# Access Compliance Report

## Public Rights-of-Way

### (Curb Ramps)

Intersection ID: 27680	Main Street: LANCASTER_HY	Cross Street: BALLANTYNE_COMMONS_PY	Location: NW
ADA ID: 774A905575A7	Ramp Type: Perp	Initial Pass/Fail: Fail	Overall Compliance: No
Severity Score: 8.75			
Codes/Mitigation Info/Possible Solution		Field Measurements/Component Compliance

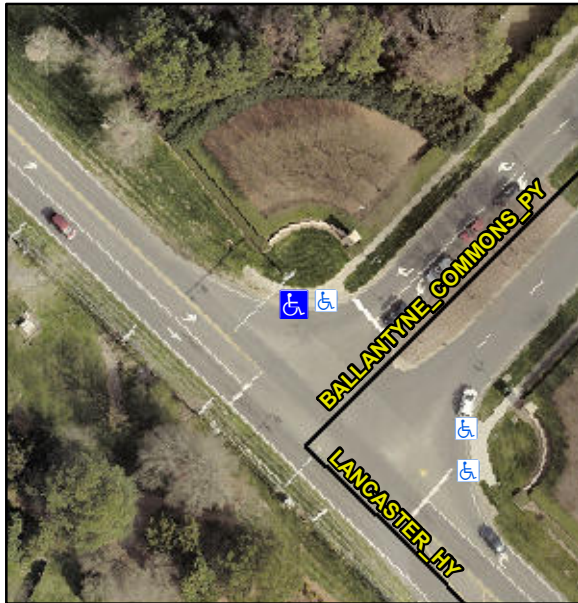
**Not Found, R304.5.1**

Compliance	Description	Data	Compliance	Description	Data
N/A	Ramp Length (in)	47.0	Yes	Ramp Slope (%)	6.3
No	Ramp Width (in)	46.0	Yes	Ramp XSlope (%)	0.6
N/A	Flare Type LT	N/A	N/A	Flare Type RT	N/A
N/A	Flare Slope LT (%)	N/A	N/A	Flare Slope RT (%)	N/A
N/A	Flare Traversable LT?	N/A	N/A	Flare Traversable RT?	N/A
N/A	Landing Length (in)	N/A	N/A	DWS Provided?	N/A
N/A	Landing Width (in)	N/A	N/A	DWS Contrast?	N/A
N/A	Landing Slope (%)	N/A	N/A	DWS Length (in)	N/A
N/A	Landing X Slope (%)	N/A	N/A	DWS Full Width?	N/A
N/A	Landing Curb? (Y/N)	N/A	N/A	DWS Offset (in)	N/A
N/A	Shared Landing?	N/A			
N/A	Gutter Ponding?	N/A	N/A	Gutter Slope (%)	N/A
N/A	Gutter Lip Ht (in)	N/A	N/A	Gutter X Slope (%)	N/A
N/A	Painted X Walk1?	No	N/A	Painted X Walk2?	N/A
	X Walk 1 Direction	To SW		X Walk 2 Direction	N/A
N/A	X Walk 1 Width (in)	N/A	N/A	X Walk 2 Width (in)	N/A
	X Walk 1 Slope (%)	5.2		X Walk 2 Slope (%)	N/A
	X Walk 1 X Slope (%)	1.0		X Walk 2 X Slope (%)	N/A

**Remove & Replace Entire Ramp.**
